Subject: WATER ENTRY FROM THE REAR DOOR	Bulletin No.: 09-008/22
	Last Issued : 03/01/2022

DESCRIPTION

Mazda3

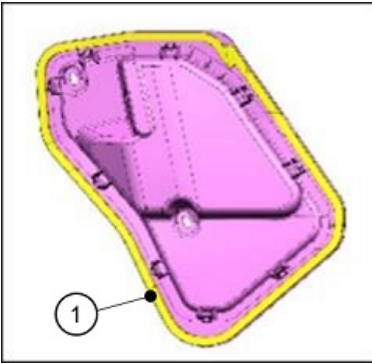
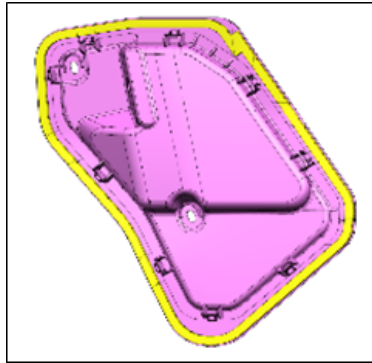
Japan built (JM1)
Modified service-hole cover
with seal material (1)

Mexico built (3MZ)
Non-modified service-hole cover

To eliminate this concern, the seal material of the service-hole cover has been changed (Japan built Mazda3) and a mass production change will be implemented in the future (Mexico built Mazda3 and CX-30).

CX-30

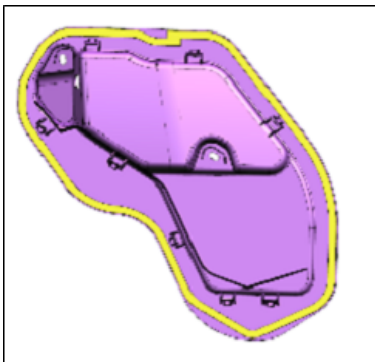
Non-modified service-hole cover

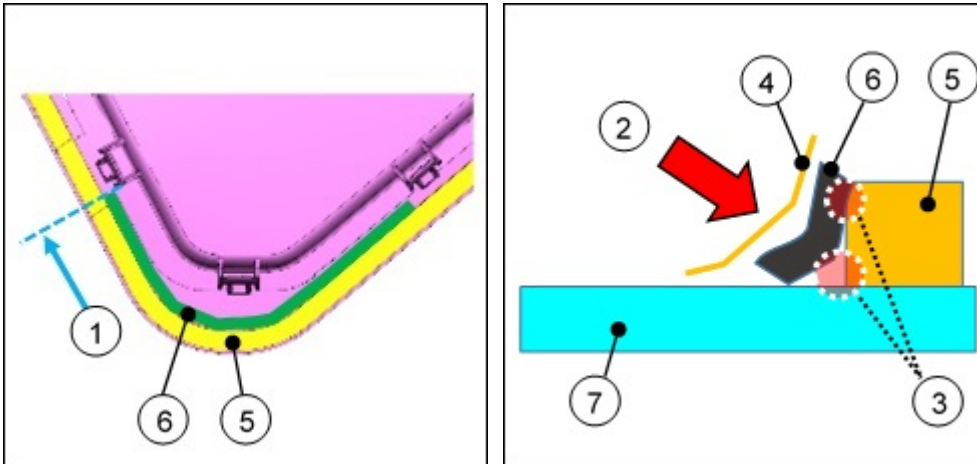
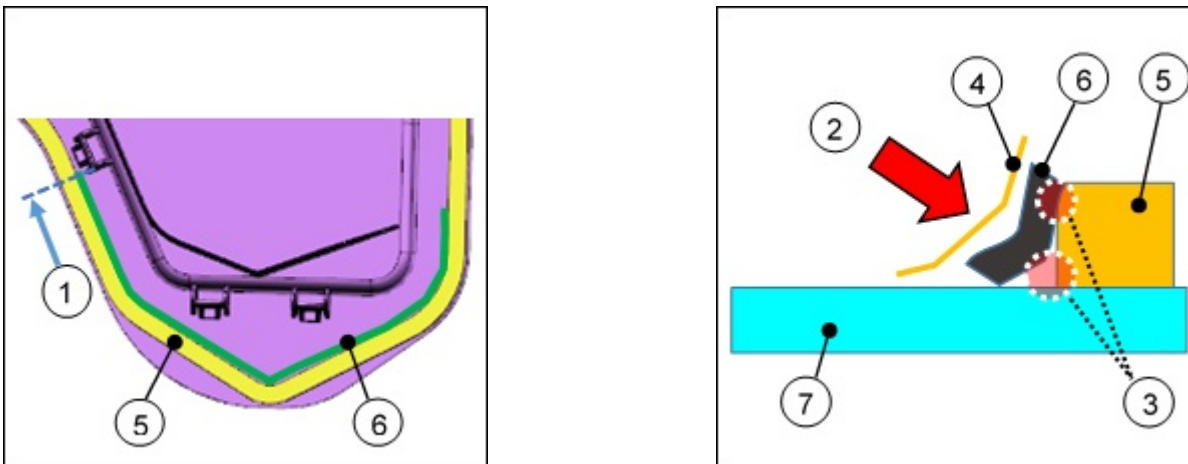
c. Apply TAPE-1 (6) as per the green line below along with the seal rubber (5).

1) Start applying TAPE-1 (6) at the edge (1) of the tab.

2) Using the release paper (4), press the tape hard (2) to fill the gap (3) between TAPE-1 (6) and the seal rubber (5) / service hole cover (7).

CORRECT (image is of CX-30)

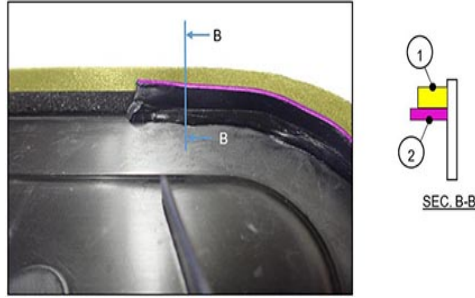
The butyl tape (2) IS sticking up at or above the height of seal rubber (1).

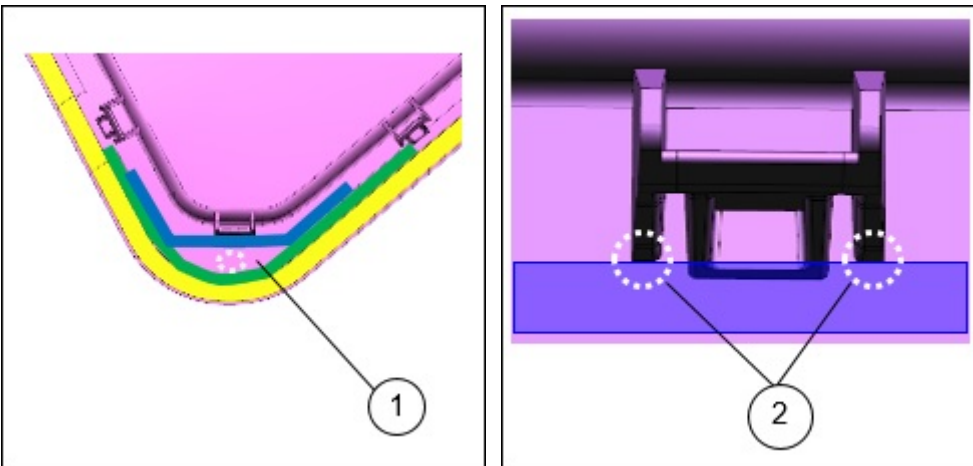
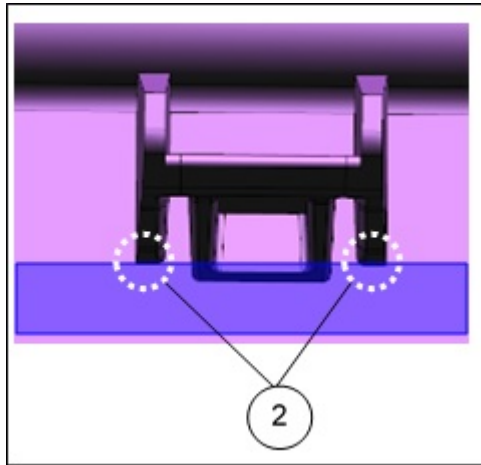
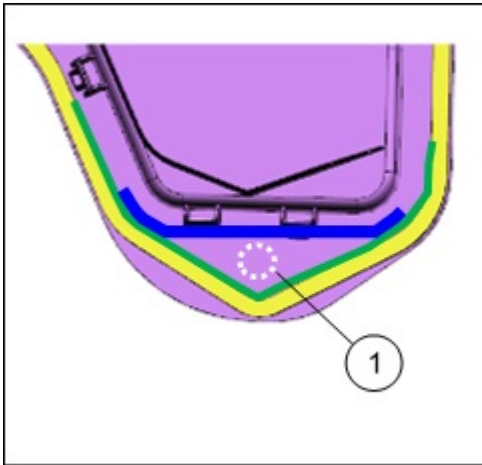
d. Apply TAPE-2 as per the blue line below.

- DO NOT fill area (1) to avoid blocking the drain hole on the door panel.
- Apply TAPE-2 along the bottom edge of the ribs (2) of the tab.
- Make sure TAPE-1 and TAPE-2 make good contact with each other when they overlap.

Examples of NOT CORRECT placement of tapes (image is of CX-30)

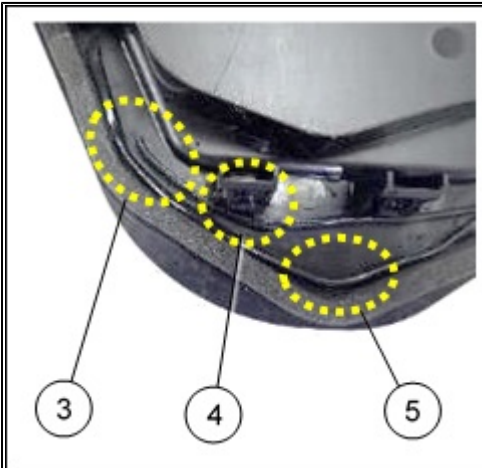
- (3) TAPE-2 does not adhere to TAPE-1.
- (4) TAPE-2 is away from the tab.
- (5) TAPE-1 does not adhere to the seal rubber.

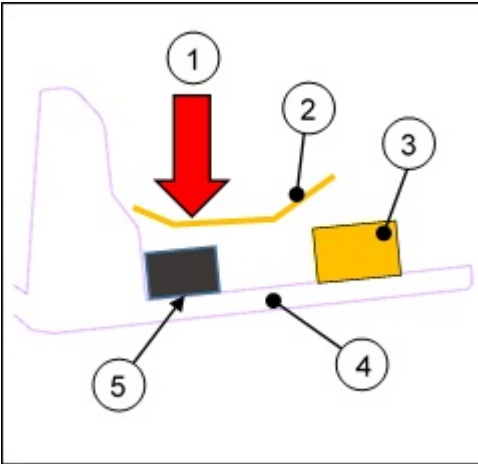
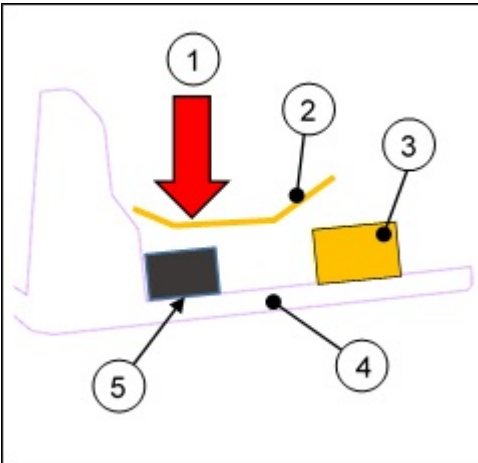
e. Press (1) the release paper (2) against TAPE-2 (5) to adhere the butyl tape to the service hole cover (4) [seal rubber (3)].
